Original Issue May 6, 2025
Revised June 9, 2025, with Contra Costa Health MRC Oversight Committee Comments

Draft Final Report
Independent Incident Investigation/Root Cause Analysis
of the
Martinez Refining Company LLC
February 1, 2025 Loss of Process Containment and Fire
for

Contra Costa Health
Attn: Nicole Heath, Michael Dossey

14.APPENDIX 5 – MRC OVERSIGHT COMMITTEE COMMENTS AND RESPONSES

**FIGURE 1
MRC PIPING ARRANGEMENT**

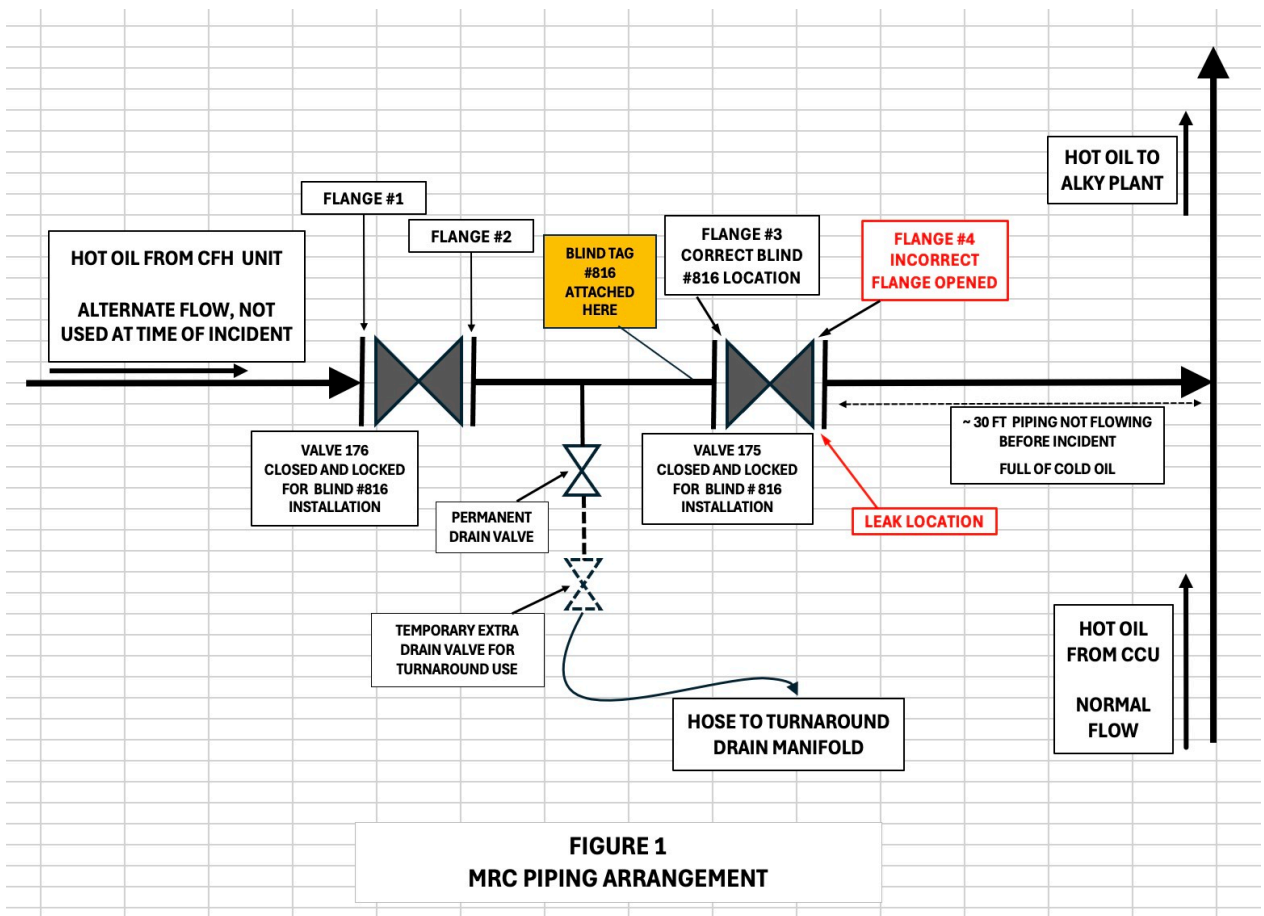
here? Operator pointed out flange with laser pointer. Also a blind tag was in place.		Figure 1, only the section between the 8" block valves would be isolated and verified to have zero energy with the bleeder valve - therefore only Flange #2 and #3 can be opened safely. If they thought Flange #4 was pointed to in the job walk, the issue of safe isolation and zero energy verification should have been raised.	
Juan Banales	Increase Operator presence during contractor maintenance work to validate that the work is being done on the proper equipment at the right level of excellence." This isn't specific enough. When should operator presence occur? For the entire time the contractors are in the field?		JEM recommended that the Operator be present once the permit is signed and remain on site until the work is at a safe state with no further risk of incident.	No change to document.
Heidi Taylor	Why did existing isolation/zero-energy verification procedures fail to account for contractor capabilities? Was the "zero energy" confirmation process flawed (e.g., incomplete pressure testing, inadequate documentation)? Why were workers able to access the incorrect flange despite locked isolation valves?		There was zero energy present on the flange that was to be blinded. The process was flawed in that the contract workers did not witness zero energy themselves. It is not clear why the contract workers opened the wrong flange. The workers said MRC Operator A and the TIMEC supervisor pointed to Flange #4 with the laser pointer, while MRC Operator A and the Timec supervisor said they pointed to Flange #3. The workers said they did not see a blind tag. A qualified fitter would recognize that with the piping arrangement shown in Figure 1, only the section between the 8" block valves would be isolated and verified to have zero energy with the bleeder valve - therefore only Flange #2 and #3 can be opened safely. If they thought Flange #4 was pointed to in the job walk, the issue of safe isolation and zero energy verification should have been raised.	No change to document.

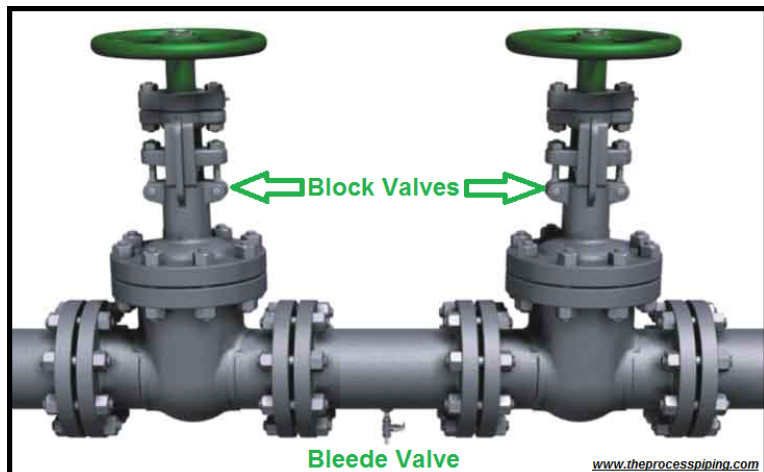
CCH	Page 11, change PBF to MRC. First bullet under contributing cause #4 conflicts with the Ishikawa diagram. Please revise.		Agree	PBF changed to MRC. Made wording consistent between Ishikawa diagram and Report Text throughout.
CCH	Page 13, Contributing Cause #2 "Positive Identification of Maintenance Work Location", this is not on Ishikawa diagram, please revise as appropriate.		Agree	Revised Ishikawa diagram to include 'Positive Identification of Maintenance Work Location'
CCH	Page 14, Inadequate Contractor Supervision, see previous comments on Ishikawa diagram stating this differently.		Agree	Made wording consistent between Ishikawa diagram and Report Text throughout.
CCH	Page 18, Contra Costa County also describes this as the management systems failures that the facility has the authority to correct.		Agree	Added this wording.
Heidi Taylor	*Comments have been rephrased to assist in readability* In your presentation slide 1, you showed a blind and there was something sticking out		Response provided in recording of 6/3/25 meeting. In the photo of the installed blind, the piece sticking out is a spacer. This is called a spectacle blind, often used	Added photo of a 'flat blind' in the report Appendix 1 - Glossary of Terms
